Fayette COUNTY

Subject: RFP #1236-B: Resurface Three Roads – Addendum #2

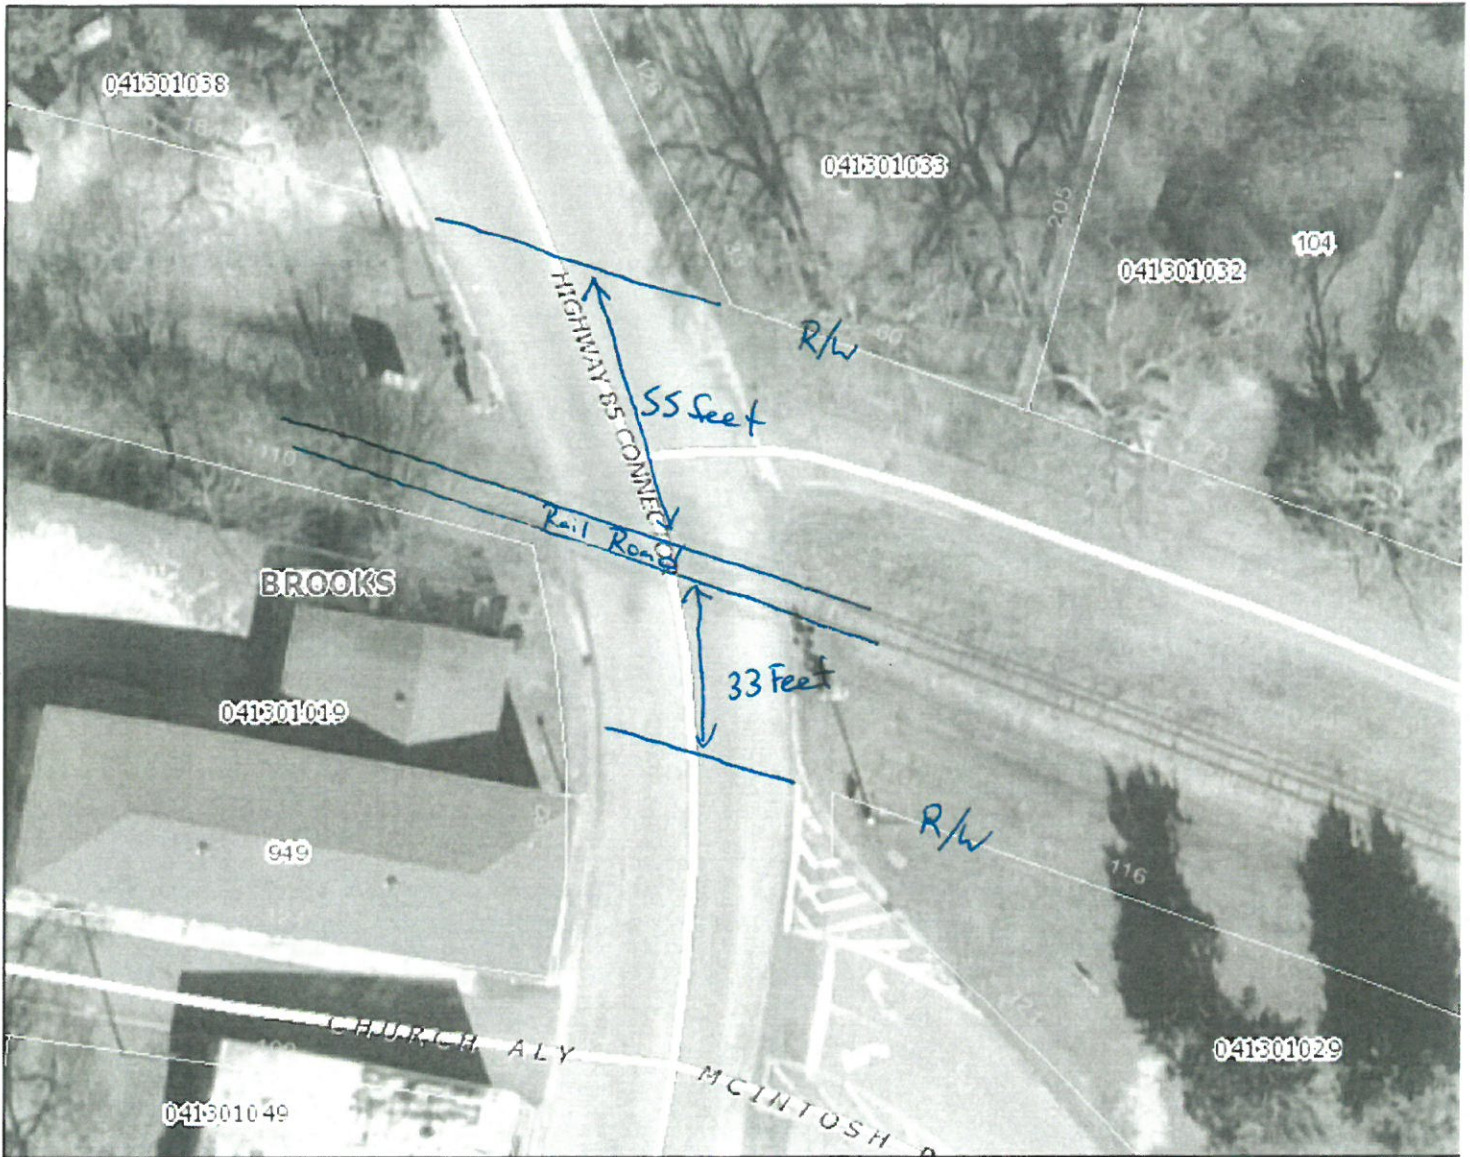
2. Page 22 of the document shows there is a railroad crossing present on the street. Typically a contractor is to stop a certain amount of feet before coming near the railroad or the contractor has to obtain a permit and permission to pave at the railroads; can clarification be provided of what we are to do at the crossroad?

The successful Contractor will be stopping 55' North of the railroad tracks and will resume 33' South of the railroad tracks, see attached.
